FAQ Number 08-0054

FAQ Title Demonstrating Compliance with Chapter 4 of NFPA 805

Plant: Oconee Nuclear Station

Date: August 19, 2010

Figure 4-3 - Fire Area by Fire Area Transition Process (Simplified)

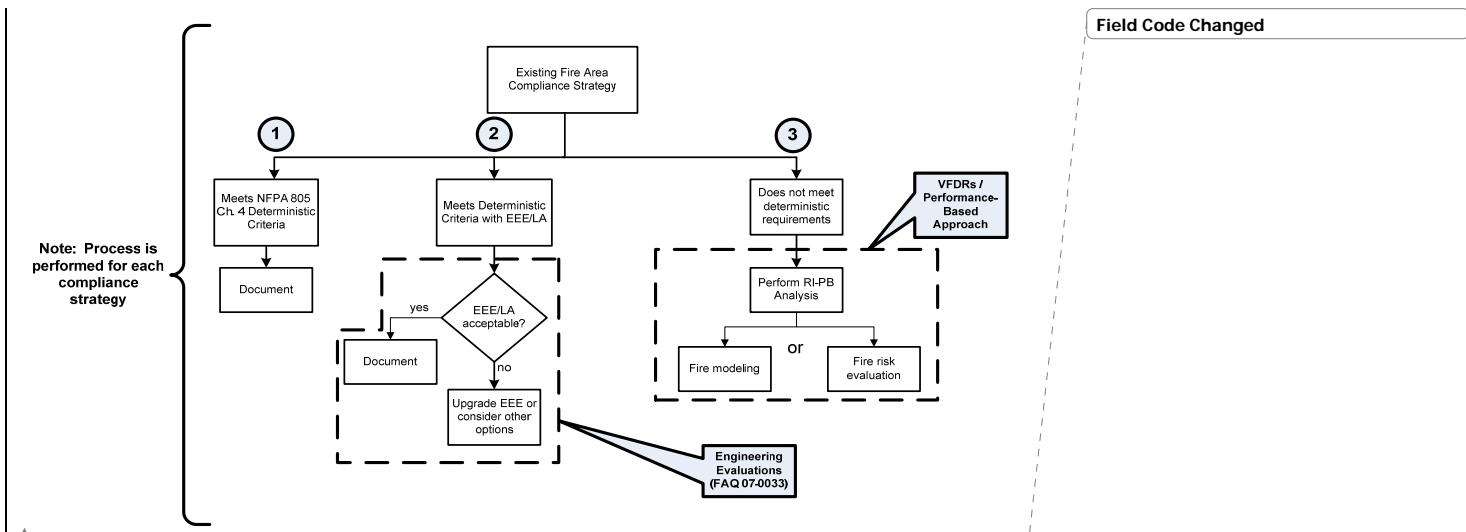
A simplified flowchart of the fire ~~area by fire~~ area transition review is provided as Figure 4-3 below.

Figure B-TBD1 – NFPA 805 Chapter 4 Compliance Assessment Process

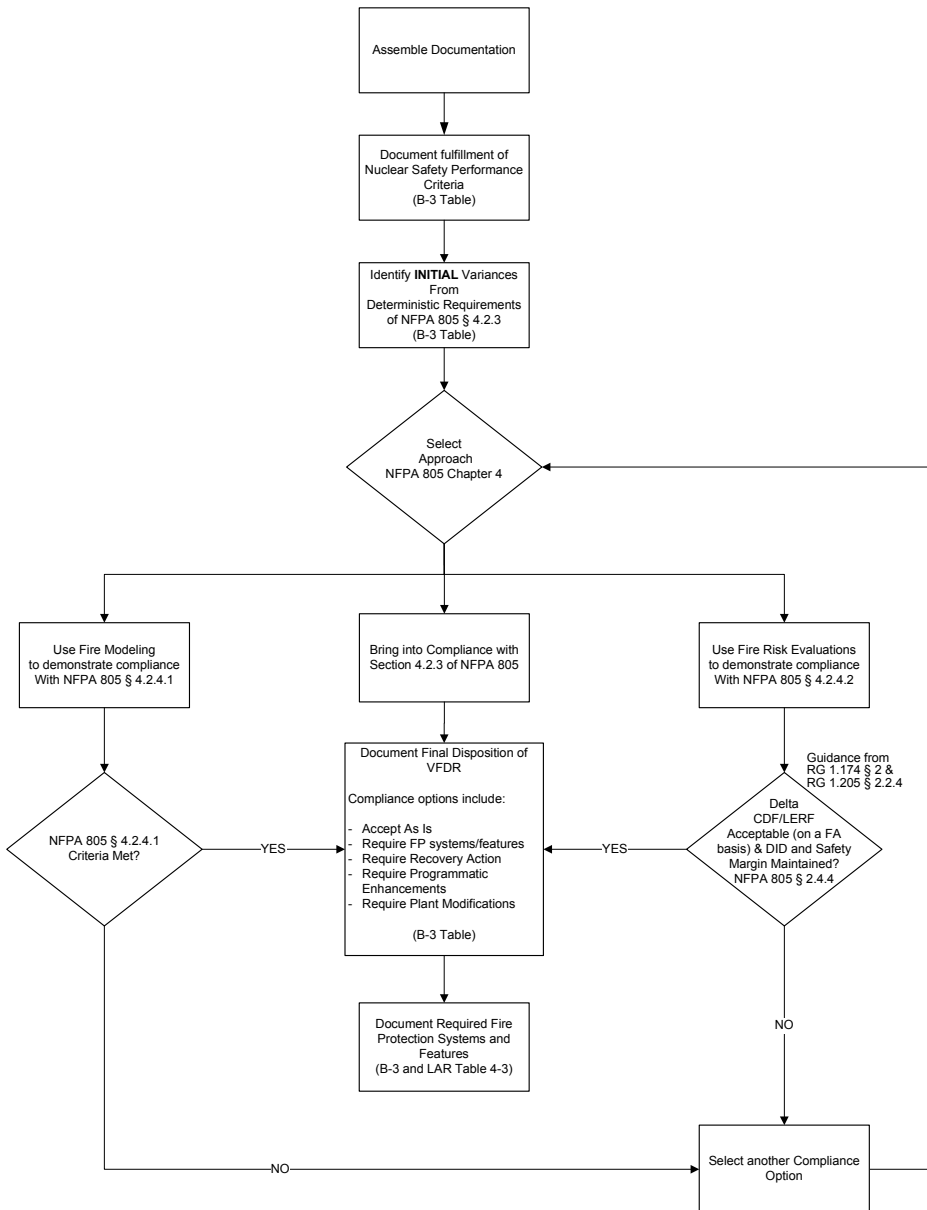
This process is depicted in Figure B-TBD1.

Figure B-TBD2 – FRE Process (NFPA 805 Transition)

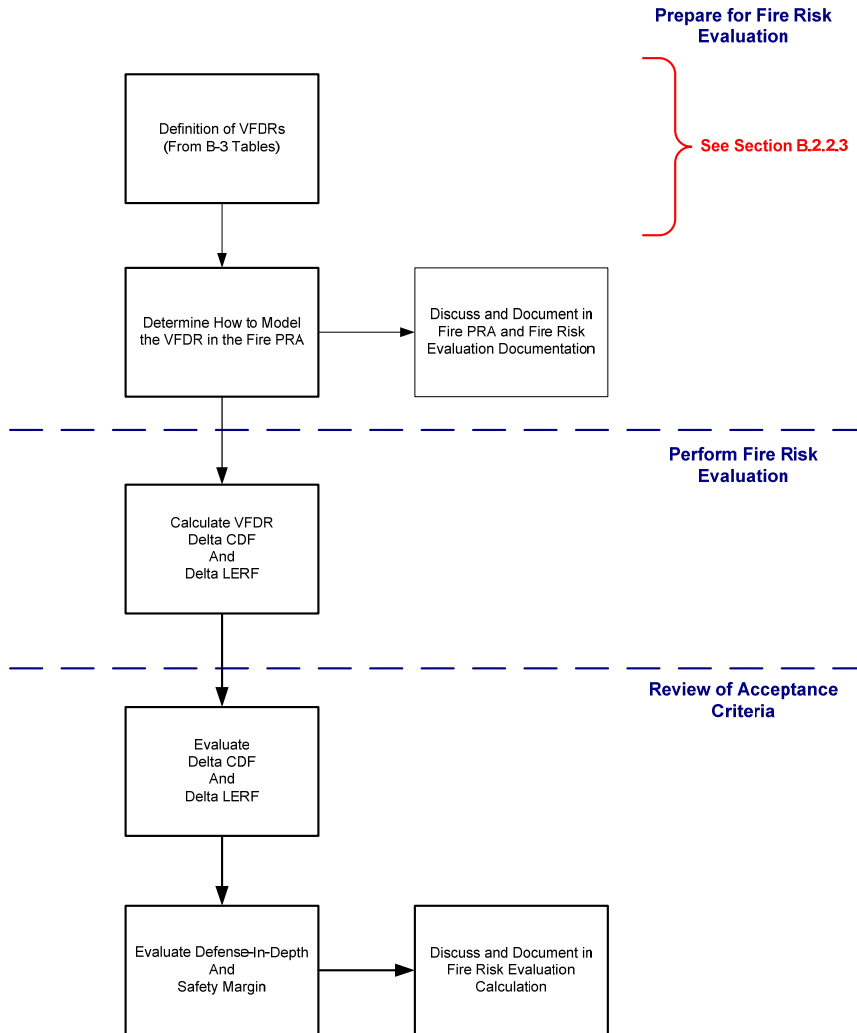
The following subsections describe the methodology used to prepare a FRE and to evaluate the results. Figure B-TBD2 is an outline of the FRE process during NFPA 805 transition.

Figure B-TBD3 – Compliant versus Variant Conditions

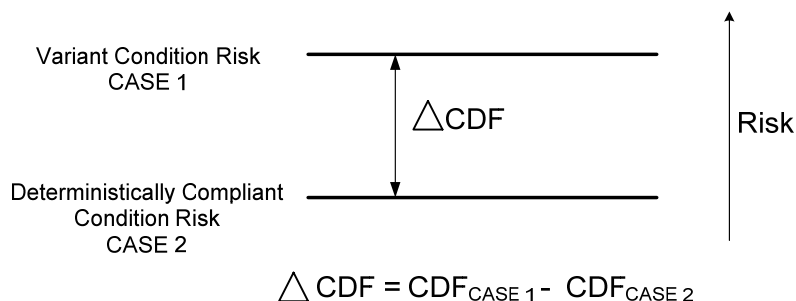
The deterministically compliant condition is defined as that plant condition or configuration that is consistent with Section 4.2.3 of NFPA 805 (shown as Case 2 in Figure B-TBD3). The variant condition or configuration, either ‘as found’ or proposed by a plant change, that is not consistent

with Section 4.2.3 of NFPA 805, is defined as the variant condition (shown as Case 1 in Figure B-TBD3).
